☒ Reviewed as Submitted
☐ Reviewed as Noted
☐ Resubmit as Noted
☐ Disapproved, Resubmit
☐ No Action Taken

FOR REVIEW AND APPROVAL 2022-05-16

Lee's Summit Logistics
Building A Lot 1
NW Corner of NE Tudor Rd. & Main St.
Lee's Summit, MO 64086

T1.1

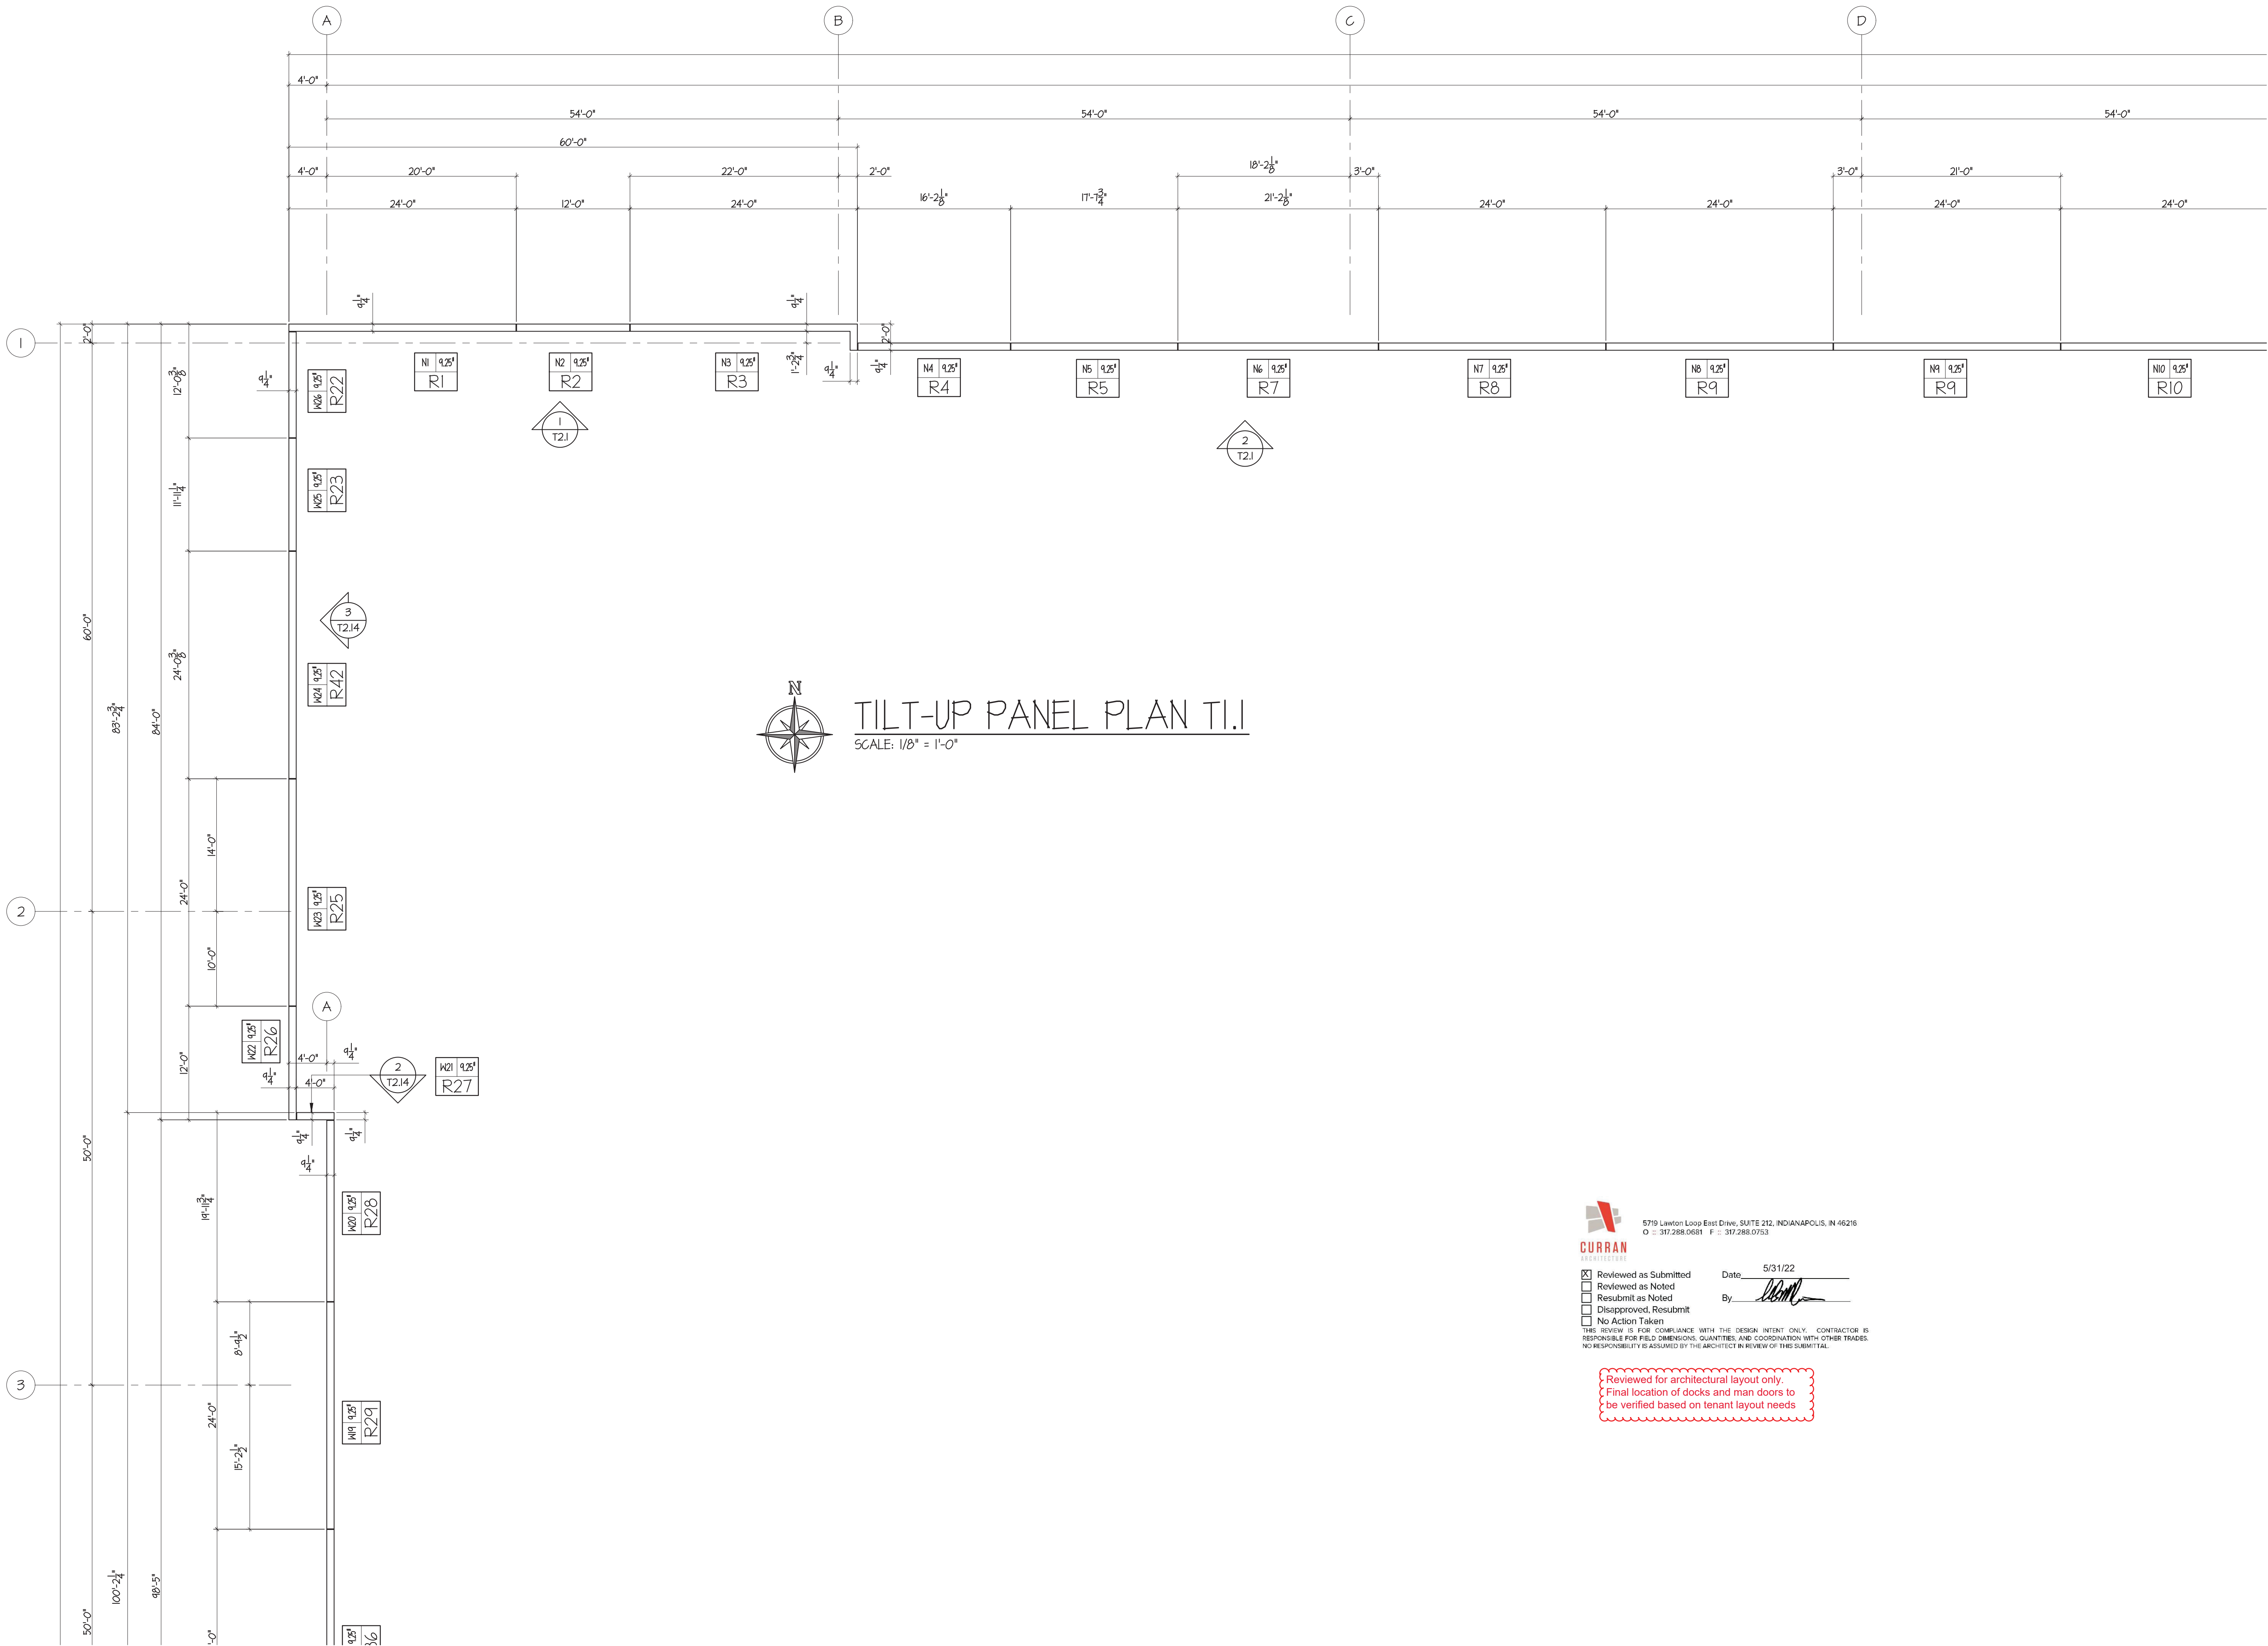
Reviewed for architectural layout only.
Final location of docks and man doors to
be verified based on tenant layout needs
